Town Council Work Session

To: Reagan Parsons, Town Manager
From: Alaina Mallette, Senior Planner
Subject: AR-24-22, Southern Pines Village Brucewood Road
Fort Bragg Federal Credit Union
Date: February 28, 2023

FORT BRAGG FEDERAL CREDIT UNION
SOUTHERN PINES BRANCH
105 BRUCEWOOD ROAD
SOUTHERN PINES, NORTH CAROLINA

A-201
SHEET 5 OF 10

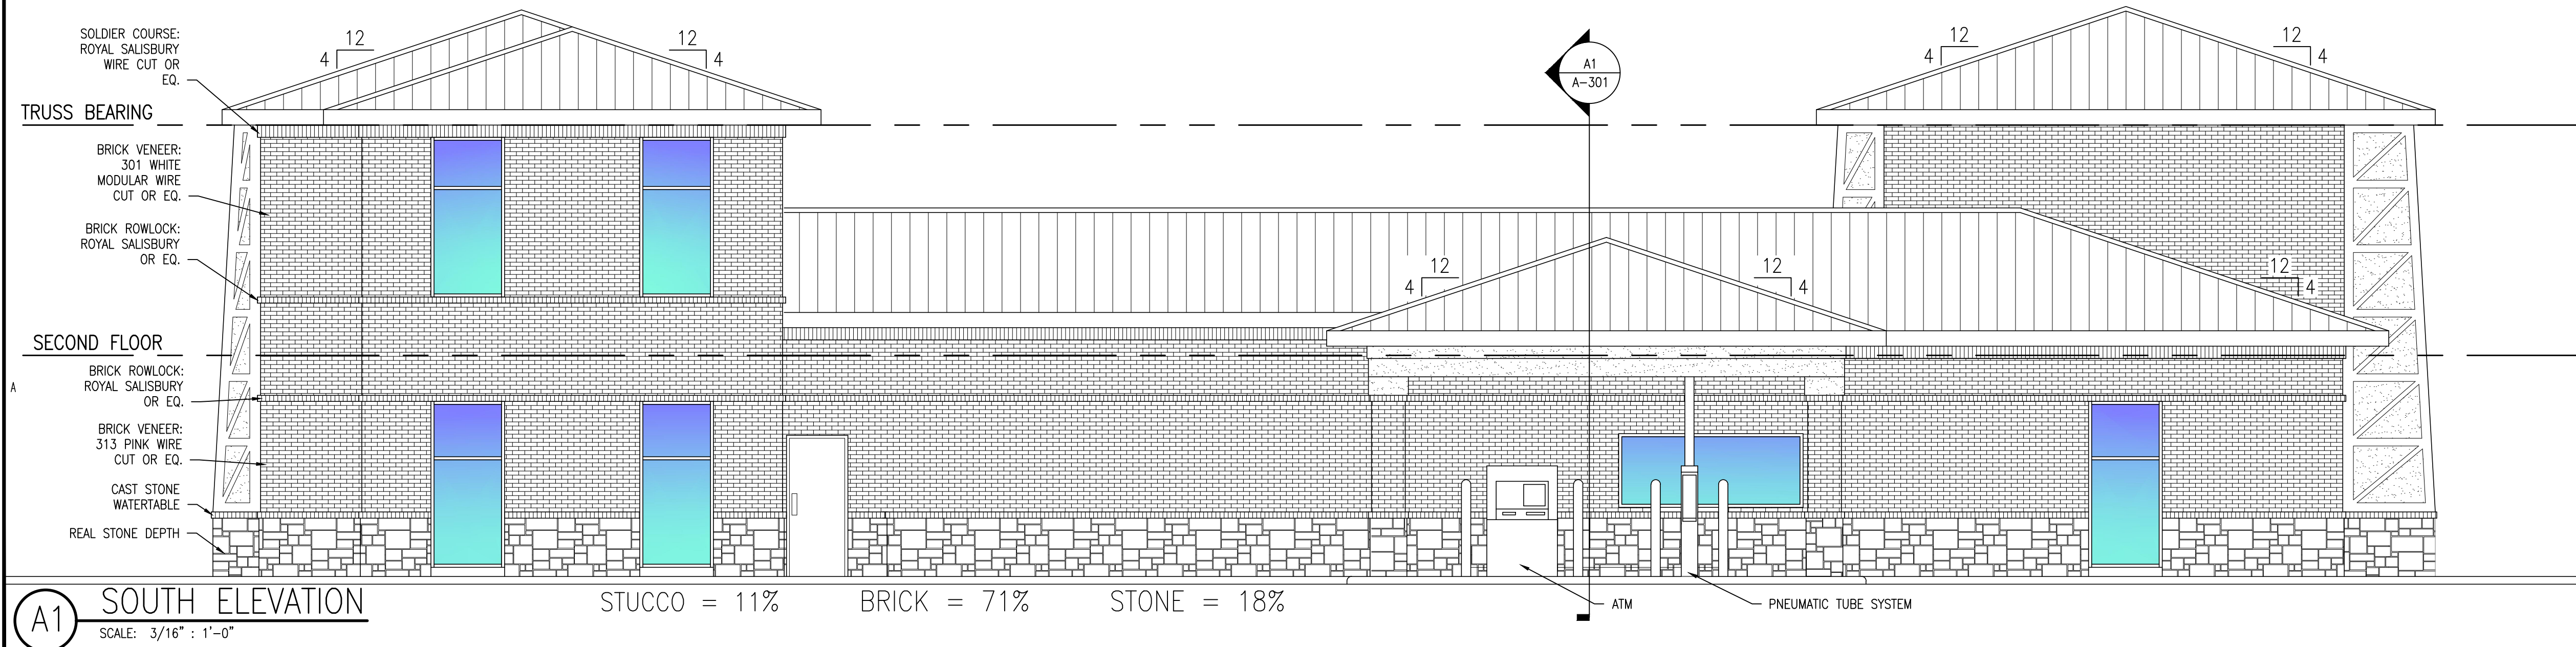
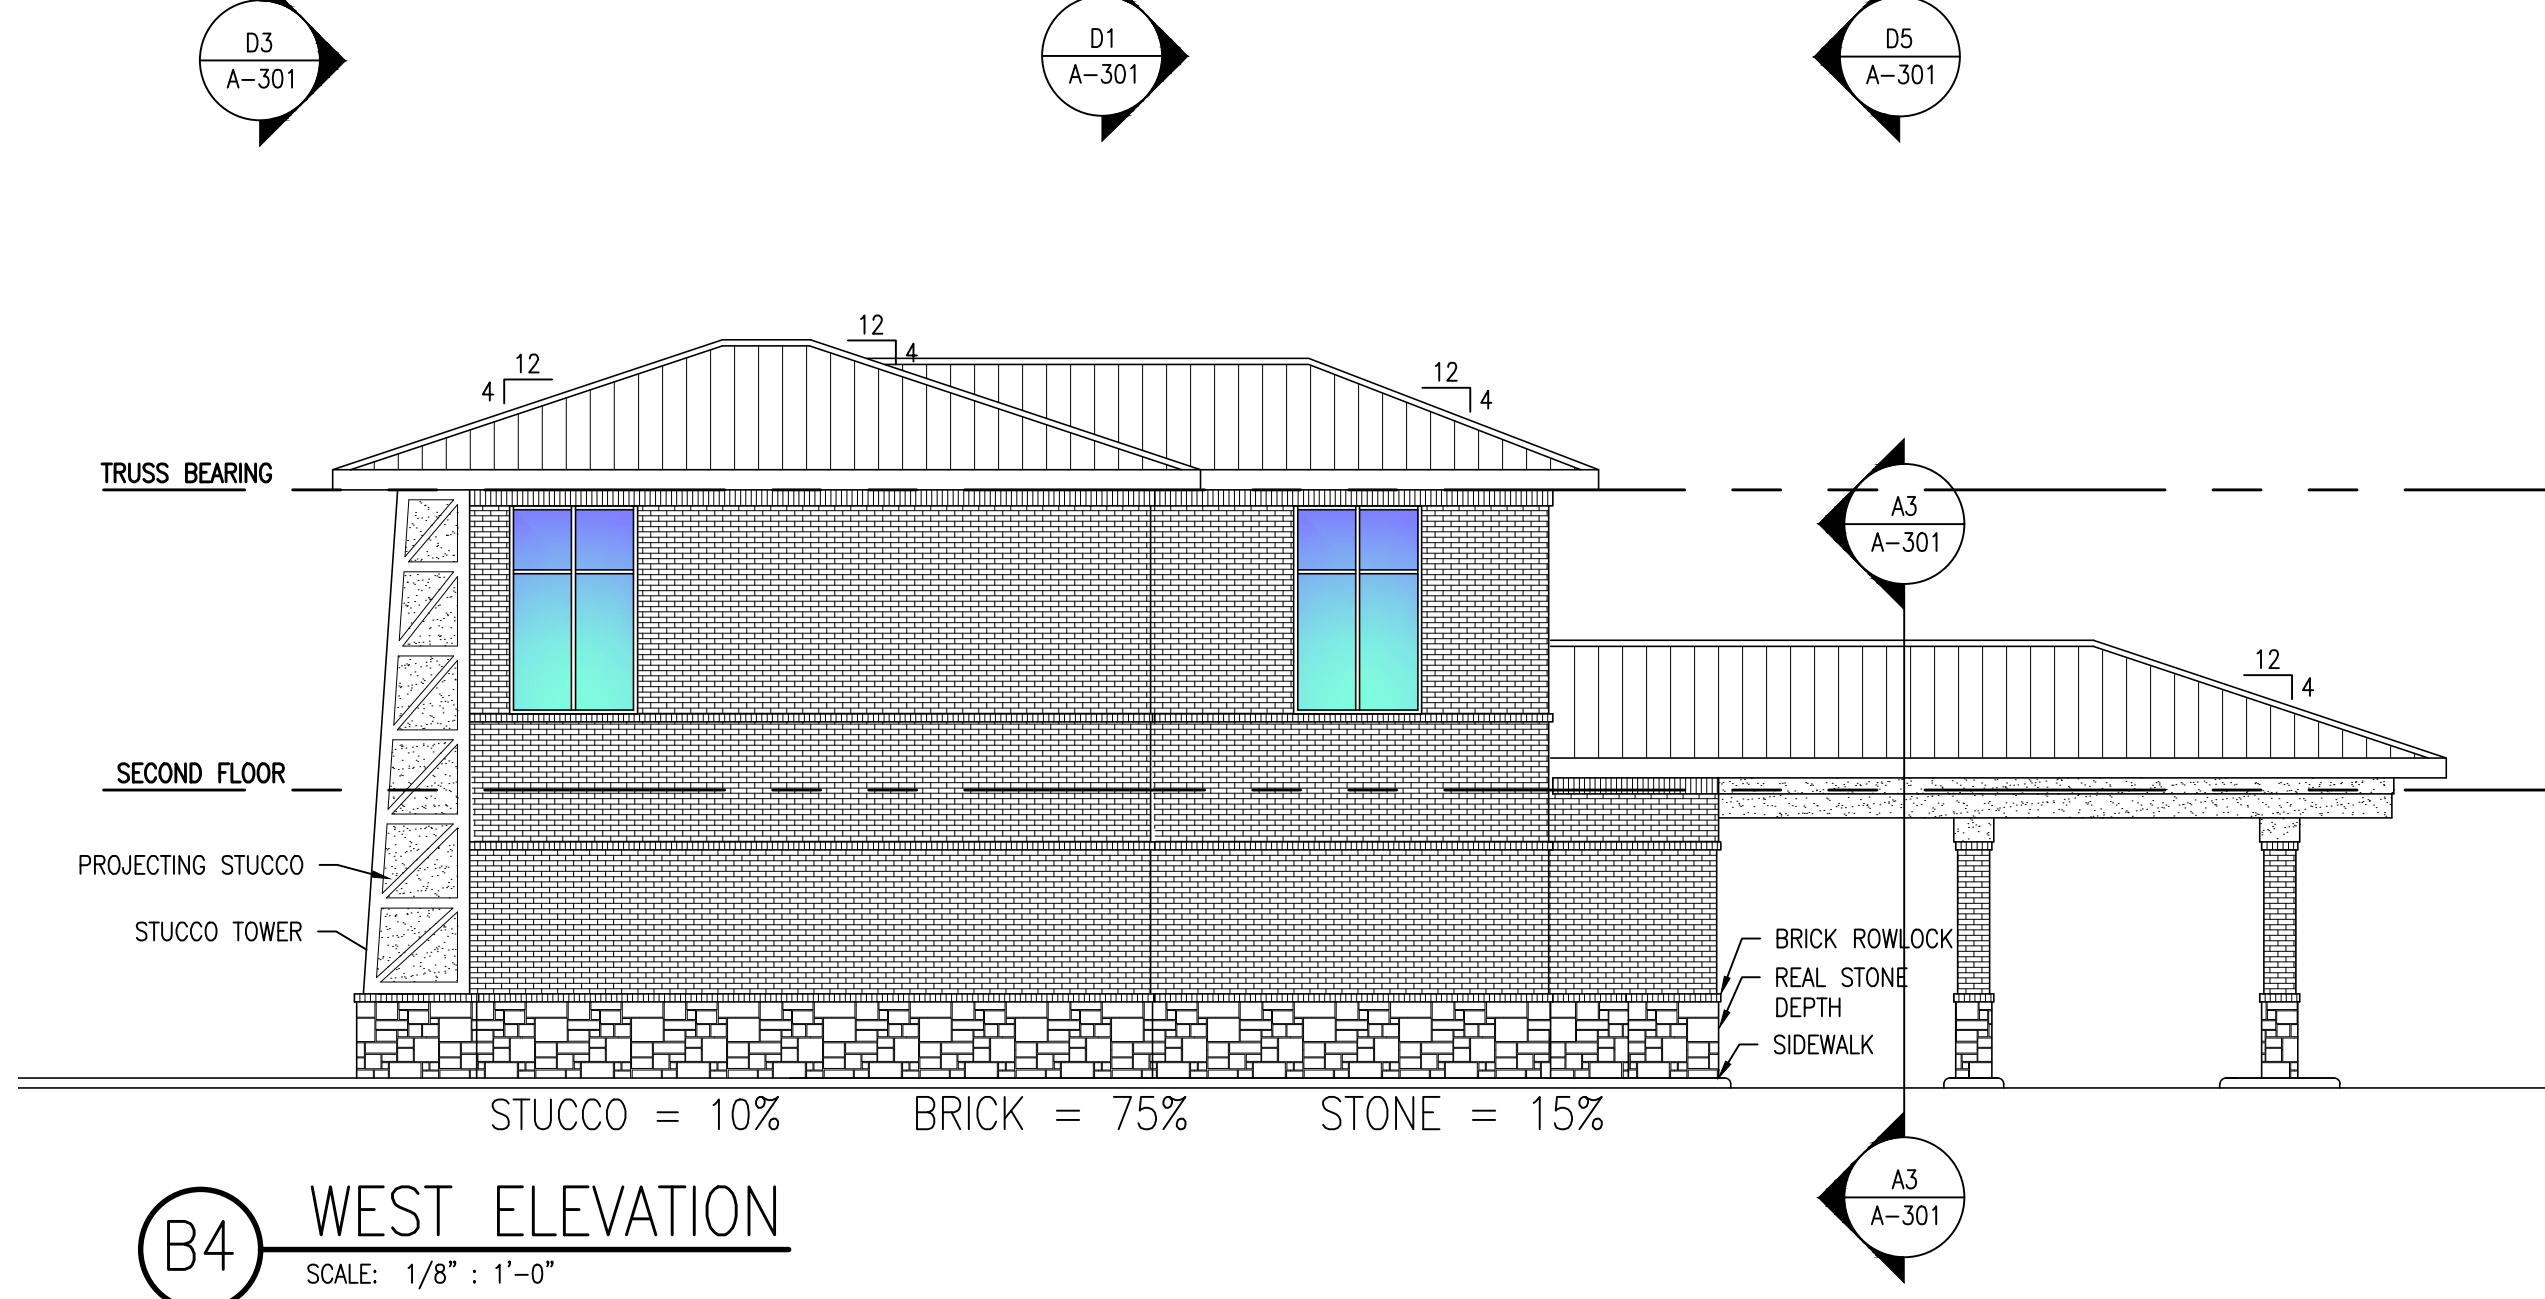
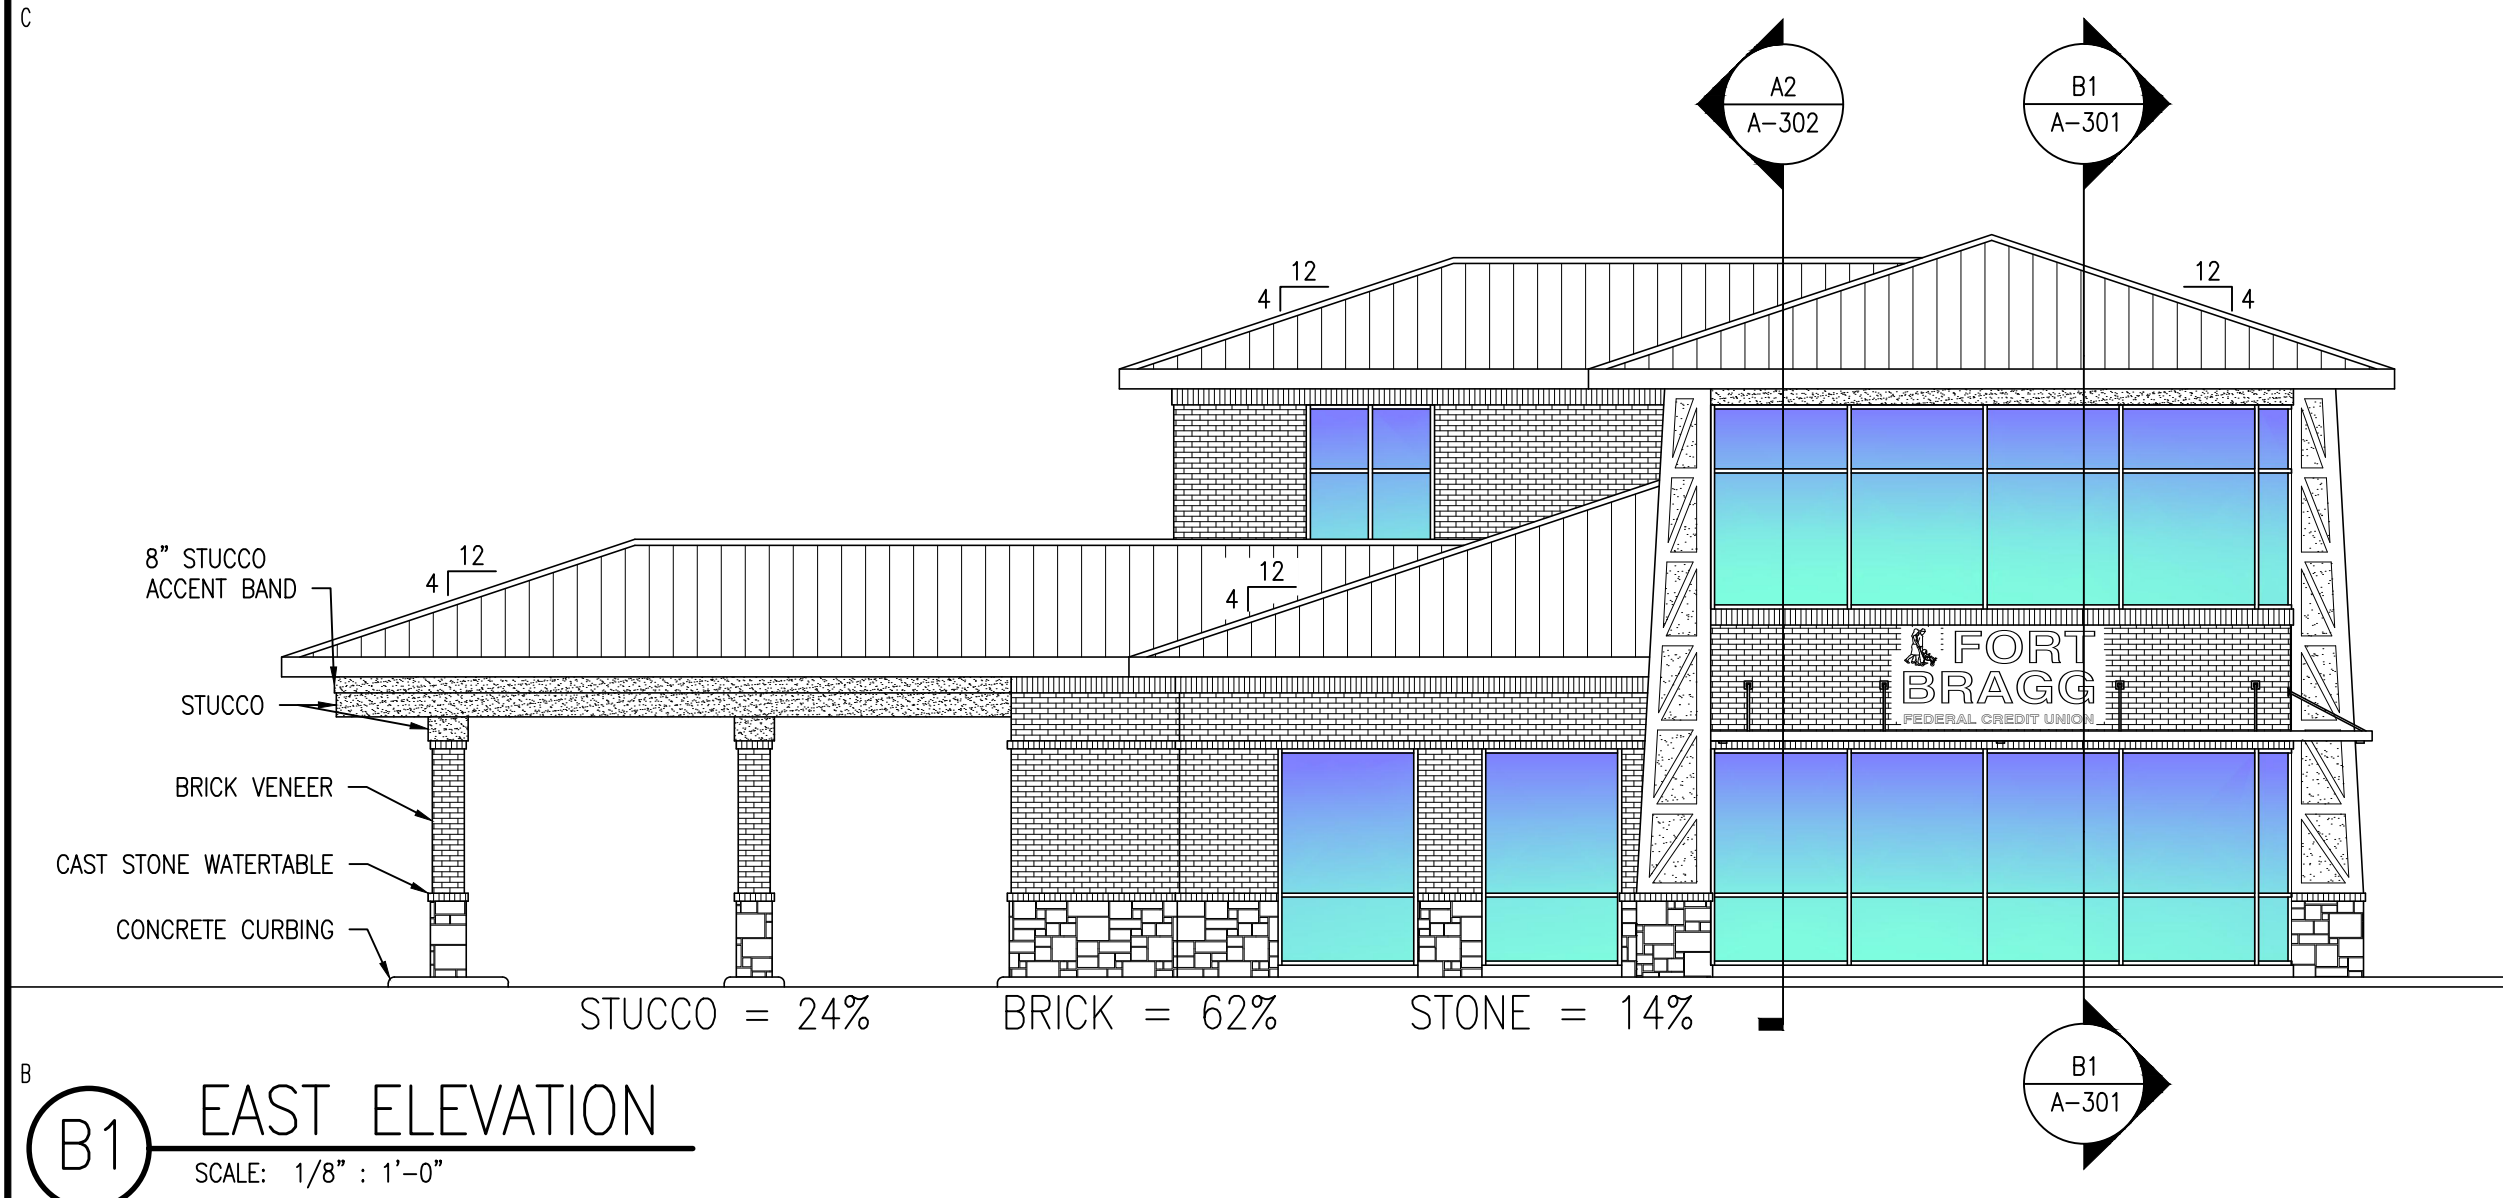
1. The exterior elevations (Sheet A-201) says sheet 5 of 10. If the other sheets are still being used for architectural guidance, can you submit those to me for review, as well?
Those sheets are specific to the building construction drawings and include interior details and other items that are not relevant to the ARB submission. Would be happy to provide them if you want to see them. I will have to get them from the architect.
2. I notice that there are callouts A1, D1, etc. on Sheet A-201. Do you have a reference table that explains what those are referring to? Perhaps those are located on one of the other 10 sheets in the original packet that we haven't received. Those are the labels for the specific elevations. D1 is the North Elevation, B1 is the East Elevation, etc.
3. What is the distance between the two entries? I believe my calculation is off, and would

2. I notice that there are callouts A1, D1, etc. on Sheet A-201. Do you have a reference table that explains what those are referring to? Perhaps those are located on one of the other 10 sheets in the original packet that we haven't received. Those are the labels for the specific elevations. D1 is the North Elevation, B1 is the East Elevation, etc.

1. The exterior elevations (Sheet A-201) says sheet 5 of 10. If the other sheets are still being used for architectural guidance, can you submit those to me for review, as well? Those sheets are specific to the building construction drawings and include interior details and other items that are not relevant to the ARB submission. Would be happy to provide them if you want to see them. I will have to get them from the architect. [See DropBox Link.](#)
<https://www.dropbox.com/sh/m4hu26il2k4tahm/AAB02VbjnAMvuaiwA6VxGoIa?dl=0>
